TECHNICAL BULLETIN

# iQ Series Instrument Security Improvements

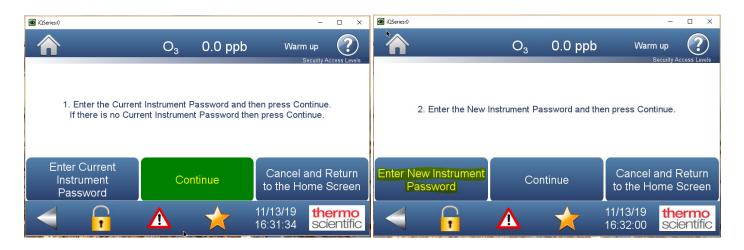
When you receive a new iQ Series instrument or after you install the new firmware to an existing iQ Series instrument, you will need to follow the steps as listed below:

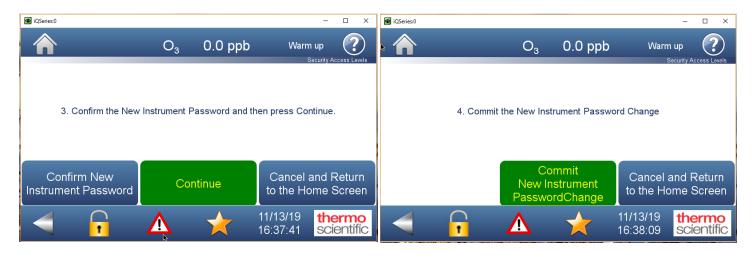
If you pressed NO on the Automatic Instrument Reboot dialog, it will go back to the Security Access Levels screen and you'll need to start the password process from scratch again.

Instrument will now reboot to enable new password
